Subject: Duke Energy Carolinas, LLC (Duke)
Catawba Nuclear Station, Units 1 and 2
Docket Numbers 50-413 and 50-414
Proposed Technical Specifications (TS) and Bases
Amendment
TS and Bases 3.7.8, Nuclear Service Water System
(NSWS)
Response to Request for Additional Information
(RAI)

RESPONSE TO REQUEST FOR ADDITIONAL INFORMATION

REQUEST FOR ADDITIONAL INFORMATION
WITH REGARD TO CATAWBA PROPOSED TECHNICAL SPECIFICATIONS
(TS) AND BASES 3.7.8, NUCLEAR SERVICE WATER SYSTEM AMENDMENT
REQUEST, DATED JULY 30, 2007 DOCKET NUMBERS 50-413/414

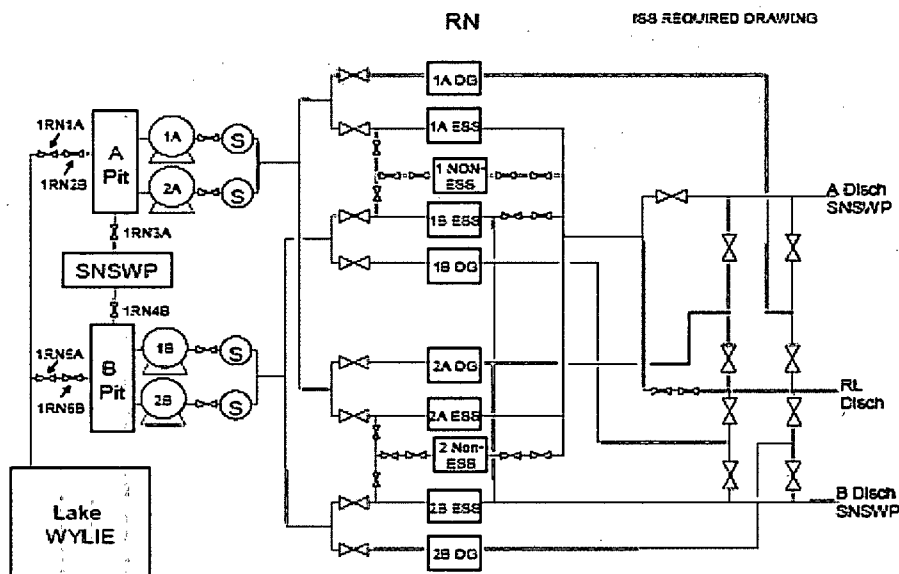
2. Terms such as "train," "header," and "loop" were used in TS and TS Bases. Clarify these terms in the context of phrasing, terminology, and format consistent with improved standard TS.

Duke Response: The standard term for a redundant subsystem utilized throughout the Improved Standard TS is "train". To this end, this term was utilized in TS 3.7.8 for the redundant NSWS subsystems when Catawba adopted the Improved Standard TS format in 1999. The Catawba TS, while written for a two-unit station, are applied to each unit individually. Therefore, each unit's TS requires two NSWS trains to be operable while in Modes 1, 2, 3, and 4. Each unit's two required NSWS trains are designated A and B (i.e., 1A and 1B for Unit 1 and 2A and 2B for Unit 2).

As indicated in the Background section of the Bases for TS 3.7.8, portions of the NSWS are shared between the Catawba units. (No safety related portions of the NSWS are shared between trains. The two NSWS trains associated with each unit are completely independent of one another.) Portions of the NSWS that are shared between Unit 1 and Unit 2 include the NSWS pits, the NSWS pumps, and certain sections of the NSWS supply and return piping located outside of the Unit 1 and Unit 2 Auxiliary Buildings. The term "loop" is used to refer to the combined Unit 1 and Unit 2 portions of same-train equipment. For example, Loop A comprises both Unit 1 and Unit 2 Train A equipment and Loop B comprises both Unit 1 and Unit 2 Train B equipment. Refer to the simplified flow diagram below for an illustration of the concepts of "train" and "loop" as they pertain to the NSWS.

This figure depicts the shared nature of the NSWS supplies (non-safety related Lake Wylie and the safety related Standby Nuclear Service Water Pond), the NSWS pits, the NSWS pumps, and the shared NSWS piping sections. It also depicts the unit-specific portions of the NSWS, which include the safety related unit related and train related supplies to each diesel generator and each essential header, as well as the non-safety related unit related supplies to each non-essential header.

The term "header", as used in the context of the NSWS and this amendment request, refers to a section of NSWS piping. There are two main NSWS supply headers from the NSWS pumphouse to the plant. The supply headers are designated A and B (for Loop A and Loop B, respectively). Each supply header is shared between Unit 1 and Unit 2. For proposed TS Condition B of the amendment request, it is necessary to utilize the term "header" as opposed to the terms "train" or "loop", since use of the terms "train" or "loop" would imply that the inoperability of other NSWS components (e.g., pumps, valves, other sections of NSWS piping) could be allowed under this Condition.
